## Roads Department – Planning Report

**Register Reference:** SD22B/0486 AI  
**Development:** Ground floor extension to rear (to create family ancillary accommodation) with internal modifications and associated site works.  
**Location:** Castle Cottage, Lucan Road, Dublin 20  
**Applicant:** Mark Lynch  
**App. Type:** Permission  
**Planning Officer:** CONOR DOYLE  
**Date Received:** 17-May-2023  
**Decision Due:** 13-Jun-2023

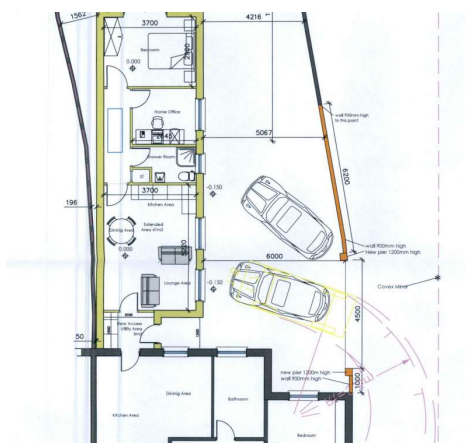
- SDCC need to receive a clear & comprehensive submission so that it could be assessed properly
- No pillars could exceed 1200mm in height; boundary wall to be reduced to 900mm max in height to expansion joint (to give required sightline)
- AutoTRAK analysis required
- The relocated entrance could maintain the same width as the existing (approx. 4.5m)
- A convex mirror would be welcomed as part of the submission (Ms Barr stated she owns the laneway and will submit a letter giving permission for the mirror to be erected there)
- Ideally the car park space would have min 6m clearance from boundary to building line of extension

The requirements of the additional information as requested by SDCC Roads have been met. Roads are satisfied with the proposed design.

1. Development to be constructed as per revised drawing.
2. The boundary walls at vehicle access points shall be limited to a maximum height of 0.9m, and any boundary pillars shall be limited to a maximum height of 1.2m, in order to improve forward visibility for vehicles.
3. The vehicular access point shall not exceed a width of 4.5 meters.
4. Any gates shall open inwards and not outwards on to laneway.
5. Convex mirror must be installed as per best practice guidelines.
